LANDSCAPE MASTERPLAN - AMENDED PROPOSED DEVELOPMENT

1.5 Reconfiguration of Parking / Refuse Holding Area

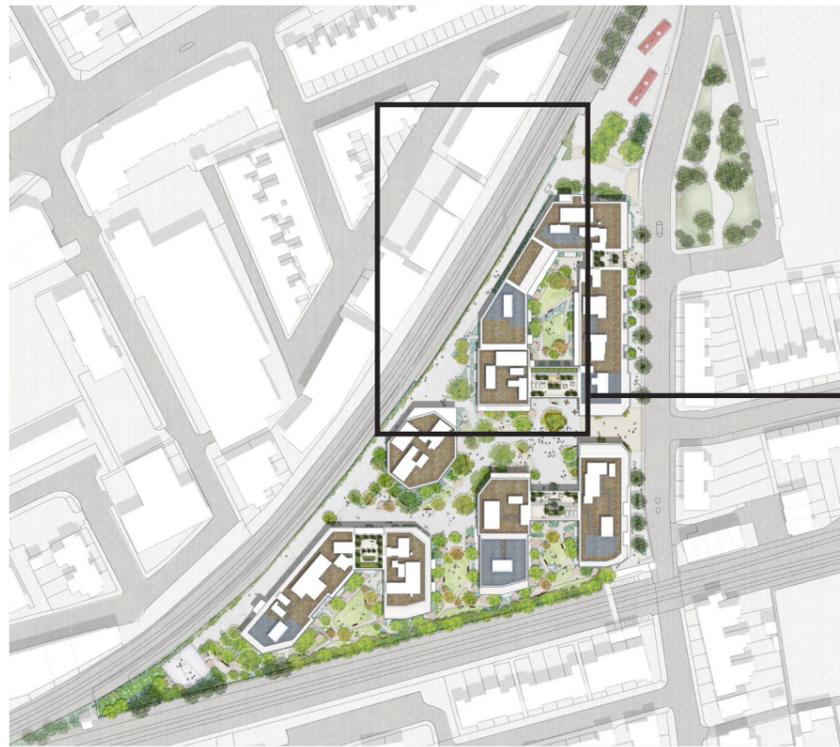
Key changes are summarised as follows with additional detail provided on the following pages:

1. Application boundary amended to align to title plan.
2. Car club bays relocated from western boundary as a result of change in red line
3. Accessible parking bays moved as a result of shift in car club bays

4. Refuse holding area relocated from western boundary as a result of change in red line
5. Courtyard design reconfigured to make up for loss of play space as a result of shift of refuse holding area

6. Minor amendments to landscape layout at South East corner as a result of change in red line
7. Adjustments to planting and path alignments to accommodate level change and optimise greening in public realm

8. Addition of sloped access routes and low retaining walls to accommodate level differences between building FFL and access road. Reconfiguration of parking, refuse collection and soft landscape adjacent to Blocks A and B to suit revised refuse collection strategy and changes to building footprint related to second stair.

9. Minor adjustments to planting and path alignment to accommodate level difference

10. Minor adjustments to landscape to align to revised door locations / fire escape routes / stair cores
11. Review of planting across site to optimise Urban Greening Factor
12. Incorporation of rain garden areas as part of SUDS strategy
13. Coordination of roof plan with revised plant / PVs / access
14. Minor adjustments to landscape due to building footprint changes related to second stairs

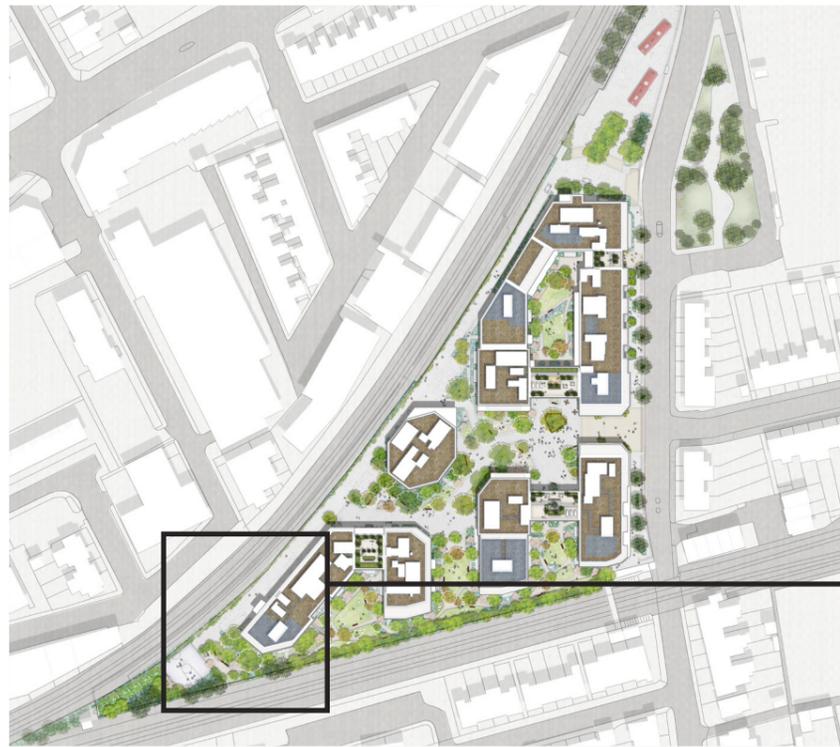
1. 2no. car club bays relocated from western boundary to parking area north of Block B in place of 2no. accessible parking bays
2. Refuse holding area relocated from western boundary to area north of Block B
3. Parking shifted south and soft landscape adjustments to suit revised refuse collection route and change to building footprint
4. Reduction in planting along boundary

DETAIL OF PARKING AREA-AMENDED SCHEME

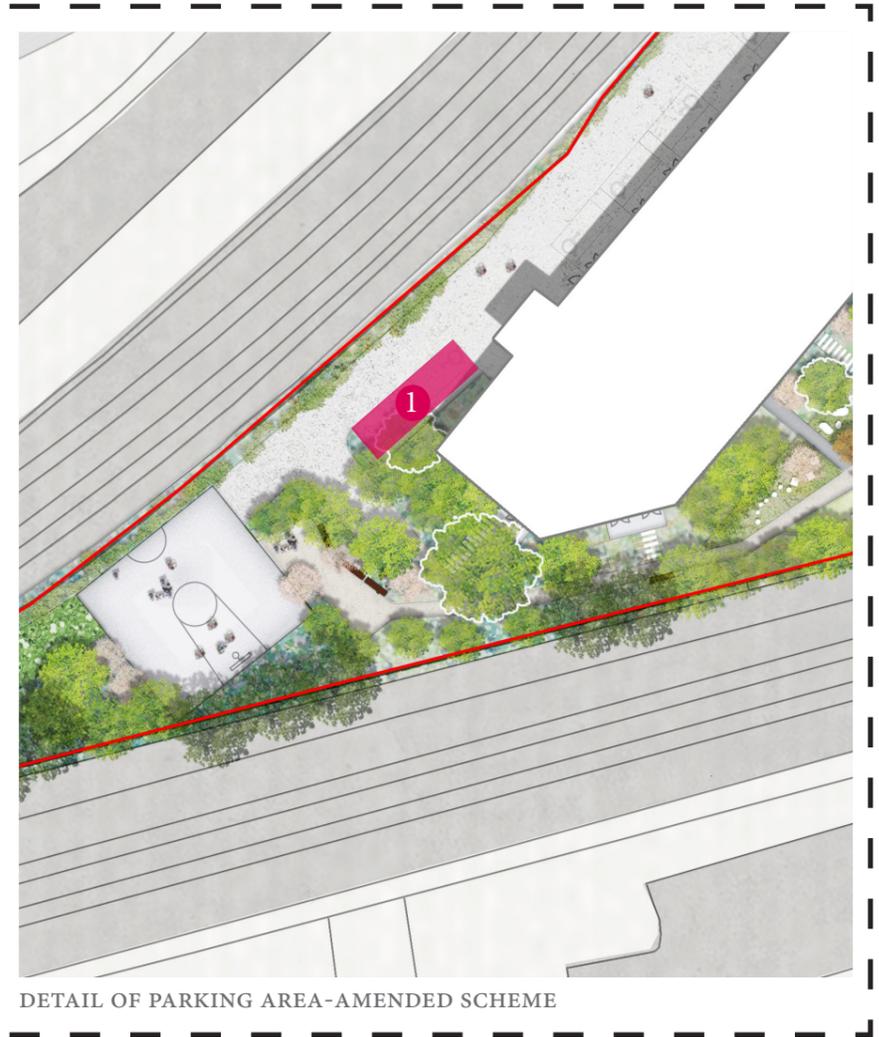
1. Re-provision of 2no. accessible parking bays displaced by car club bays. Note: proposed trees affected have been relocated elsewhere meaning no reduction in overall number of trees within the development

1.6 Revised Layout to South East Corner

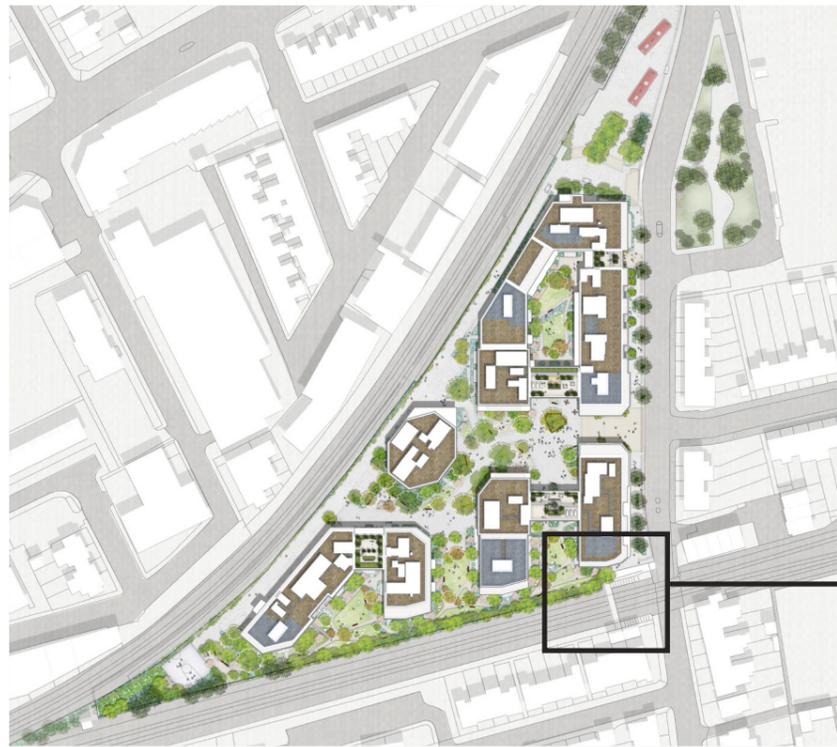
- 1. Reconfiguration of courtyard to reflect revised redline and extend 0-4 play space by 20m² to mitigate for loss of play space with relocation of refuse holding area
- 2. Adjustment of public realm layout to revised red line
- 3. Adjustment of courtyard path and gate to align to revised red line / public realm
